#### REGULAR MEETING OF THE BIRMINGHAM PLANNING BOARD

**WEDNESDAY JUNE 8, 2022 – 7:30 PM**

SUBJECT: 1160 Grant Street – Ortiz Educare – SLUP and Final Site Plan Review

RE: Final Site Plan Review Comments 1160 Grant, Ortiz EduCare, LLC

#### 1160 Grant

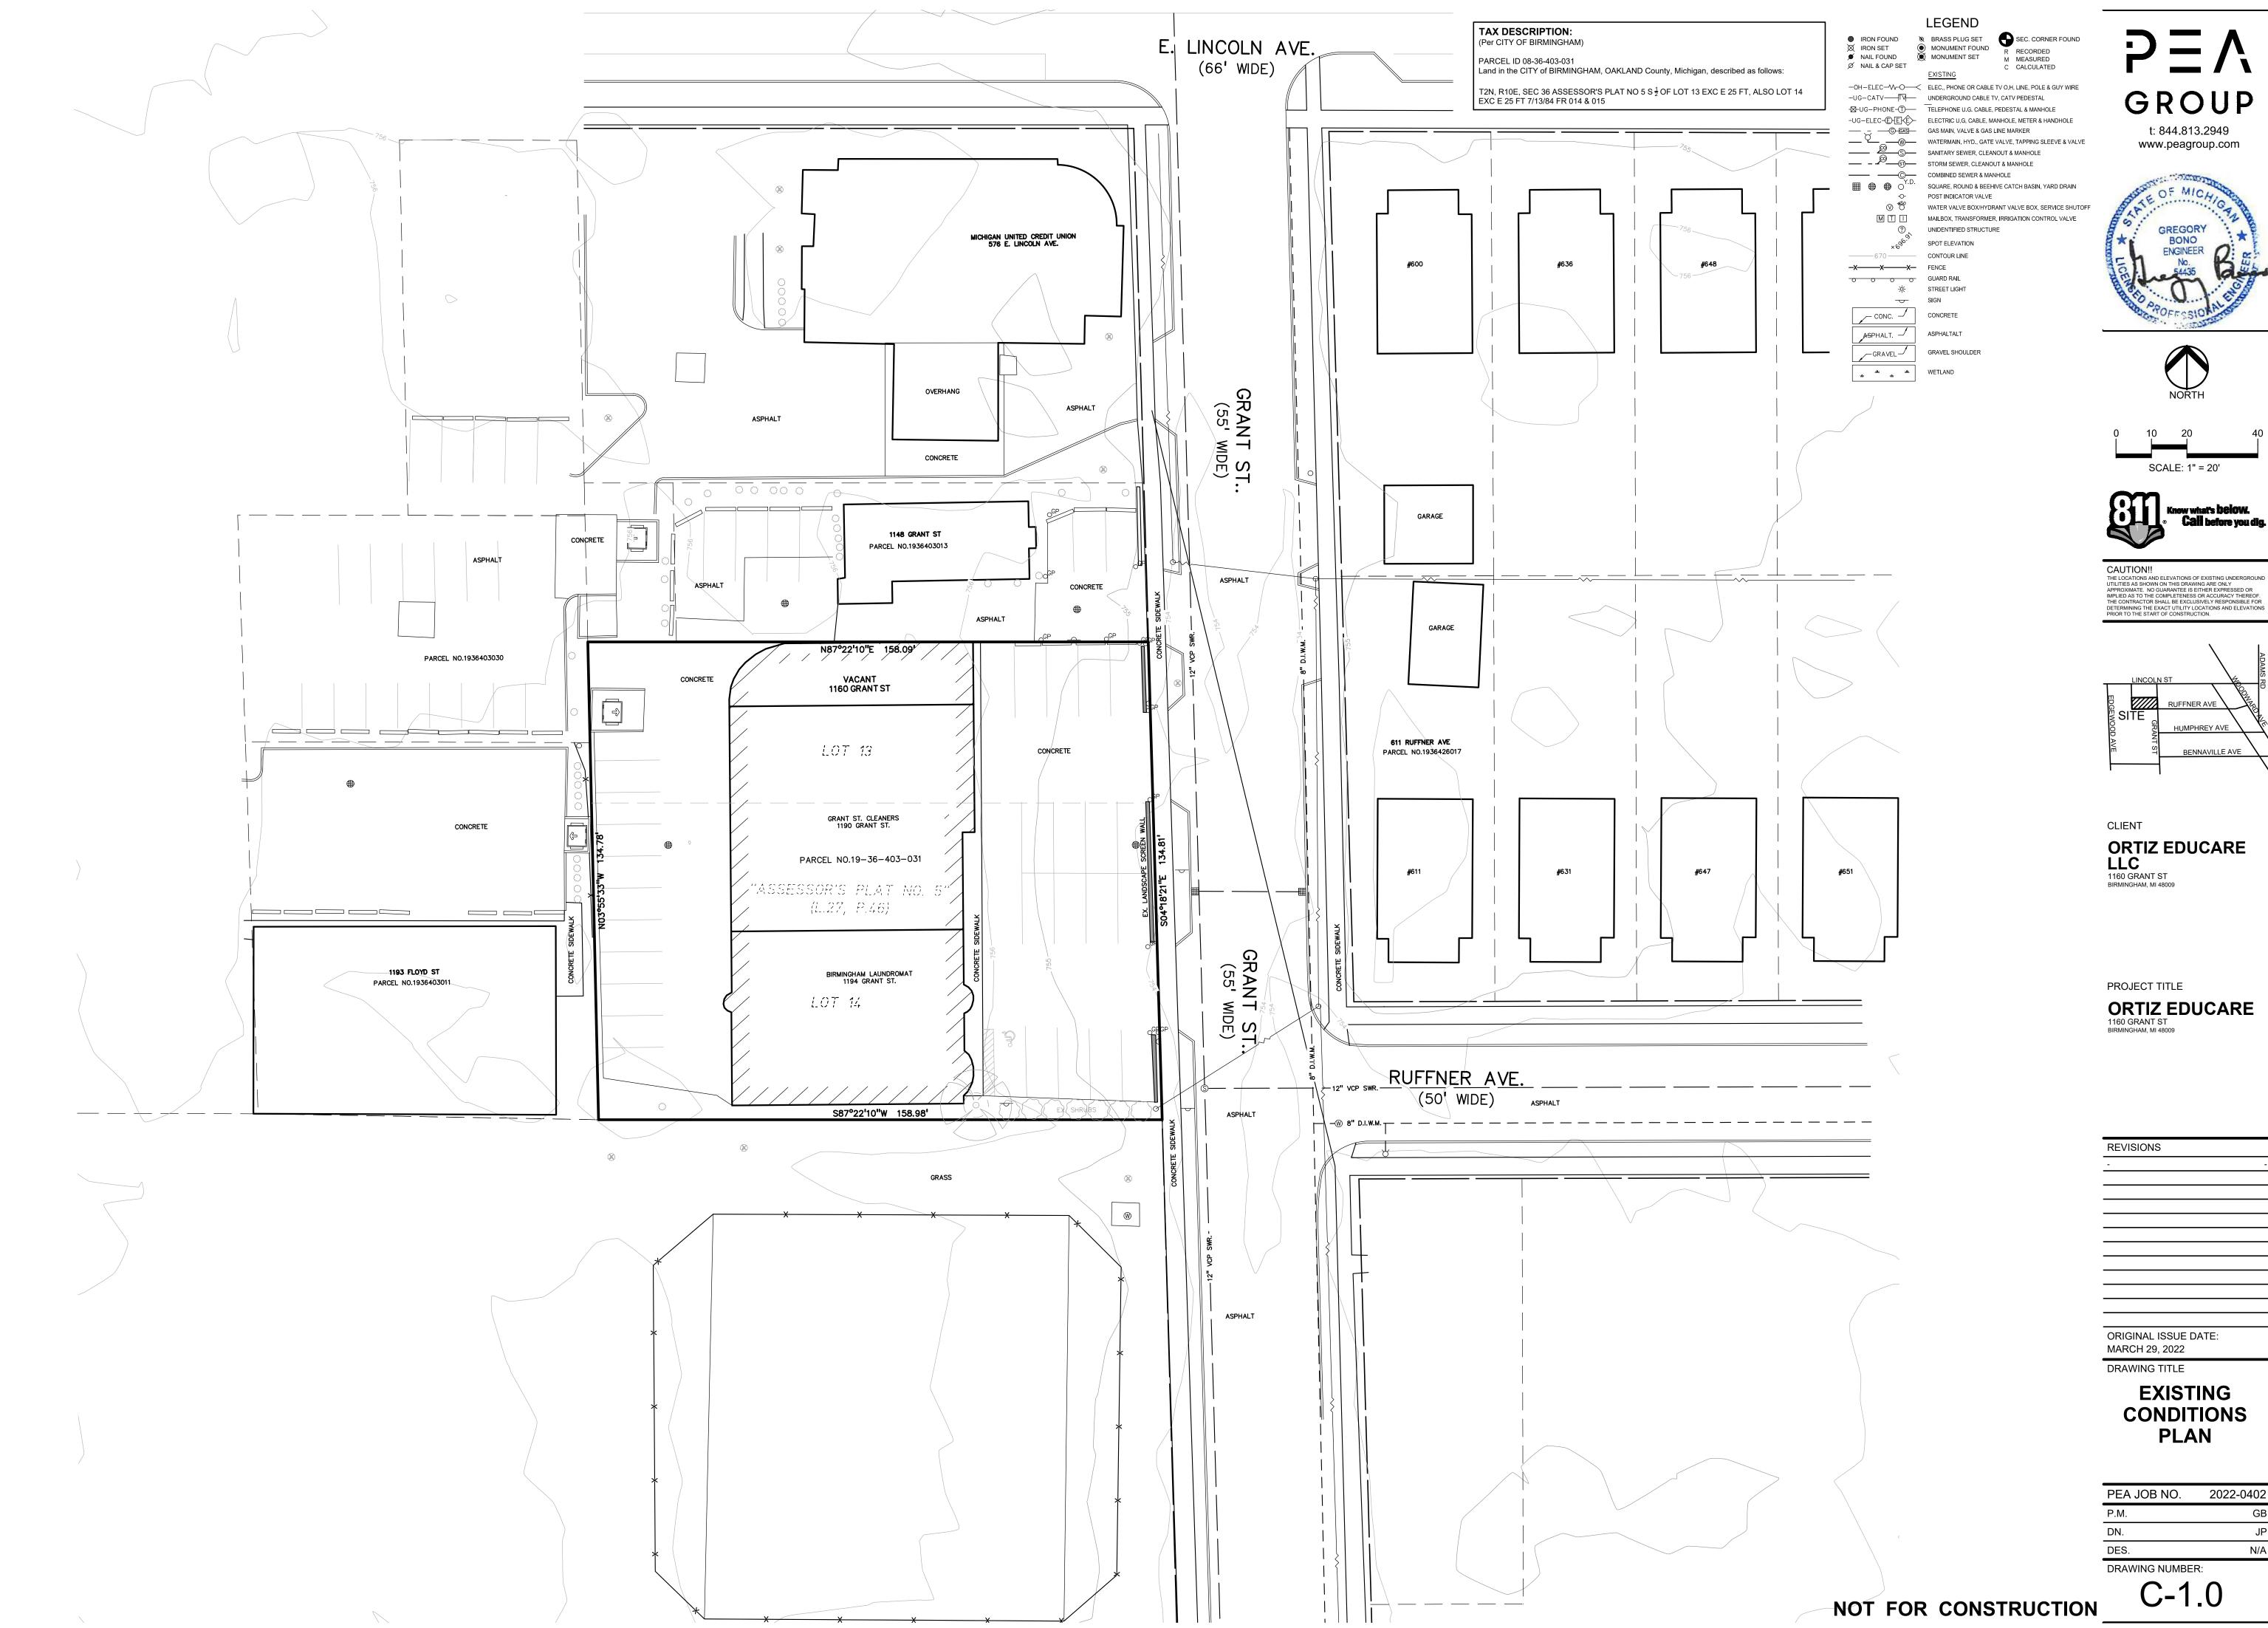
- 1. Follow and reference on plans the International Fire Code 2015 ed.
- 2. Provide 3A rated ABC fire extinguishers where specified by Fire Marshal.
- 3. Provide egress lighting per International Fire Code 2015 ed. language.
- 4. Egress doors to be compliant with proper door hardware (lever handle, panic bar, paddle ect.)
